PETITION NO: Z-24

ZONING COMMENTS:

Planning Staff Analysis

Date: Revised June 20, 2011

REVISED
 RECEIVED
 JUN 16 2011
 COBB CO. COMM. DEV. AGENCY
 ZONING DIVISION

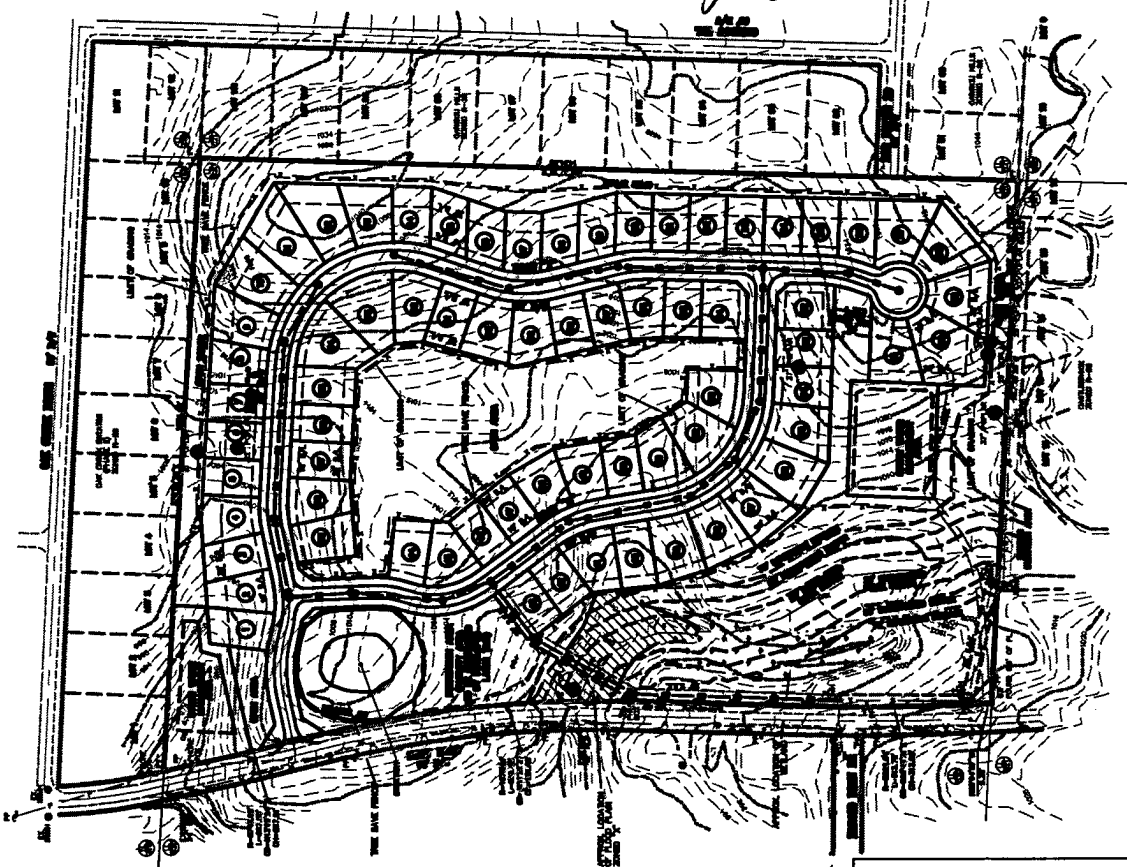
Applicant is requesting to rezone the property to the R-15/OSC category for the development of a 69-lot residential subdivision. The revised site plan received June 16, 2011 indicates that 11.09 acres (or 35%) of the tract has been set aside as open space for the proposed development. The houses for the proposed development will be comprised of traditional, detached single-family homes, with a minimum house size of 2,000 square feet. The proposal also indicates that a recreation/amenity area may be determined later by the developer. The plan also indicates a 40-foot open space area around the exterior boundaries of the subject property.

1. Both detention ponds must be located on separate parcels with adequate direct access from the public right-of-way. The northern most detention pond is located directly adjacent to a neighboring existing residential subdivision. Adequate landscaping must be provided to screen this pond from the existing residences.

1. Overall residential development shall be compatible with neighboring residential uses. Submitted, revised site plan received on June 16th shows typical lot sizes of 6,500 sf. Consider increasing lot sizes to be more attuned to neighboring residential uses which range from 14,000 sf. in Castelbrooke to 24,000 sf. in Caribou Hills to the east. Mitchell Falls, a 7 unit Conservation Subdivision (CS) across Shaw Road, contains typical lots sizes around 8,700.

2. No portion of floodplain, wetland area, cemetery or impervious community areas may be used in calculating density. Need to subtract wetlands, cemetery and any impervious community or recreation areas from overall acreage in calculating density. Since the documented floodplain is Zone X or 500 yr. flood, it can be included as part of the overall development density calculation.

3. Recreation Area must be constructed with pervious material since it is calculated as part of open space.

4. Stormwater management areas need to be identified as structural or non-structural. If stormwater management area is structural then it can not be calculated within open space and be subtracted from total open space area.

5. Wetlands can only account for 75% of required open space. The total wetland area is approximately 8% of required open space so entire wetland area can be calculated within open space. Because Floodplain is Zone X or 500 yr floodplain there is no need to include it as part of the 75% requirement.
